Re: Safety Defect Report (07V-503 revised)

Recall Bulletin 71003

SUBJECT:
Relocating
Electrical
Components
And Sealing
Electrical
Controls
Compartment

Figure 2

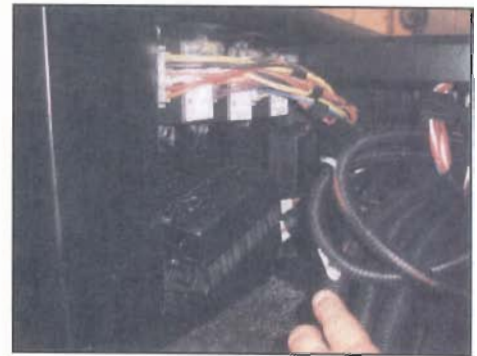
15. If slide-out room controllers were determined to need relocation in Step 14, remove the installation screws securing them to the floor of the electrical compartment. Retain screws for reassembly.
16. Locate an area of the compartment wall that is of sufficient size to re-locate the three slide-out room controllers. Make sure the wiring harnesses will reach to the new location. If sufficient space or wiring harness length is unavailable, it may be necessary to slightly adjust the location of the Fuse/Relay Block on the compartment wall in order to provide enough area for the slide-out controllers to be mounted. See Figure 2.

FIGURE 5
Cut hole and notch as shown using measurements taken in Step 23, then cut Polyurethane Panel into two pieces using the vertical center-line of the hole.

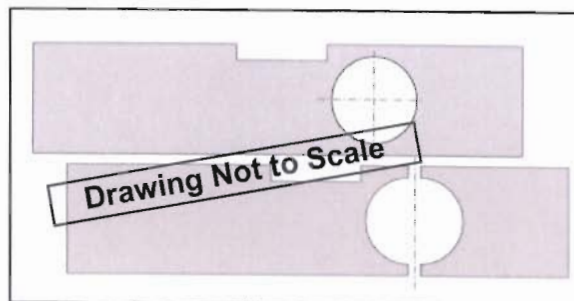
22. Working from underneath the motor home, bundle together all wires exiting the Battery Control Center compartment through the open space between the PACO beam and the back edge of the compartment floor. Use wire ties to secure.
23. Measure and record the approximate center location of the bundle of wiring that exits the rear of the compartment containing the Battery Control Center. This measurement will determine where to locate a 4-inch diameter hole, to be cut in a new Polyurethane Panel in the next Step. Additionally, measure and record the location of a notch to be cut in the new Polyurethane Panel for the PACO Beam Rivet Bracket. Refer to Figure 5.

24. Use a hole saw to cut a 4-inch diameter hole in the new piece of 8" x 22 1/4" Polyurethane Panel (BCC Housing Panel), for the wiring auto loom, according to the measurements recorded in Step 23. See Figures 5 and 6.
25. Use a jigsaw with a fine-tooth blade to cut a notch for the PACO Beam Rivet Bracket. Cut along the vertical center-line of the 4-inch diameter hole to separate the BCC Housing Panel into two pieces. See Figures 5 and 6.

FIGURE 8

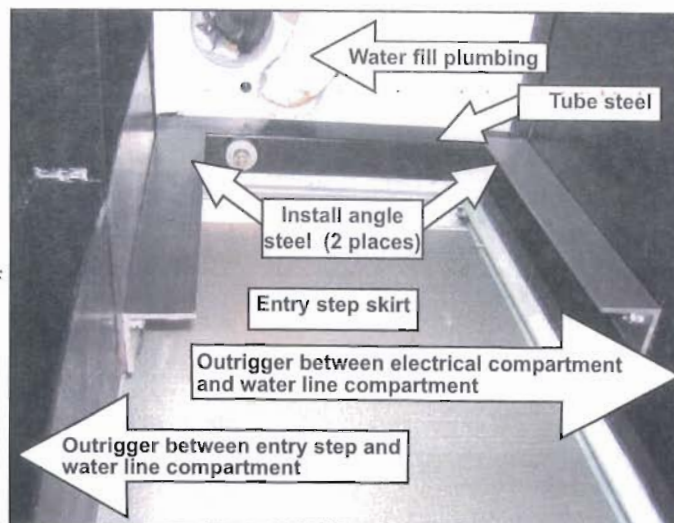
29. Position a 12" length of angle steel vertically onto the outrigger on one side of the water line compartment, directly below the tube steel framing behind the entry step skirt, as shown in Figure 8. Fasten with two #12-14 x 1" Tek Screws. Fasten a second piece of angle steel onto the outrigger on the opposite side of this compartment.

NOTE: One side of each of the two pieces of angle steel should be flush with the inner surface of the tube steel after installation. See Figure 8.

Fasten angle steel to left and right side of compartment behind entry step skirt. Edge of new angle steel should be flush with existing tube steel.

FIGURE 13

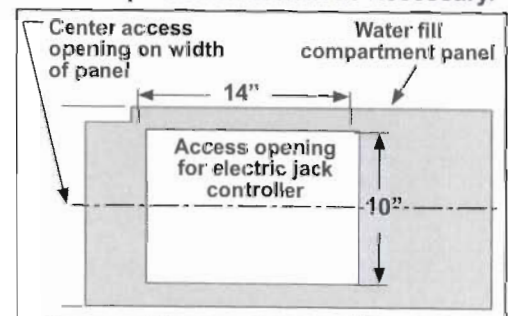
NOTE: The opening should be centered on the 13" width of the Panel, and be located at least 4" from the notched end. See Figure 13.

FIGURE 14

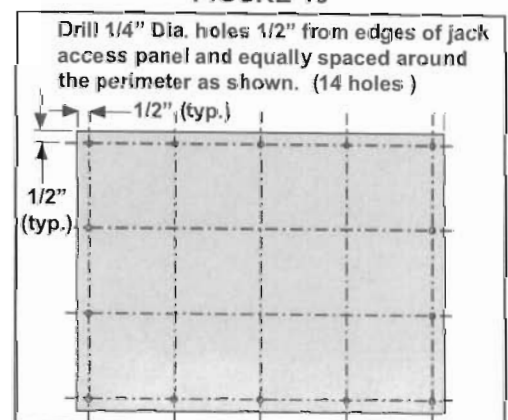
36. Locate and drill 1/4" holes around the perimeter of a new 12" x 16" Polyurethane Panel (Service Panel) according to the diagram in Figure 14. (There will be 14 holes to drill.)
37. Apply EPDM Compression Seal to the outer perimeter of one side of the Service Panel. On the opposite side, use a broad-tip permanent marker to label the Service Panel: "Access for Electric Jack Controller". Refer to Figures 11 and 14.
38. Center the Service Panel over the opening cut in the Water Fill Compartment Bottom Panel that was fabricated in Steps 34-35. Fasten using #12-14 x 1" Tek Screws at pre-drilled locations.
- NOTE:** Be certain the Service Panel will be accessible after installation of the Water Fill Compartment Bottom Panel. Refer to Figure 11.
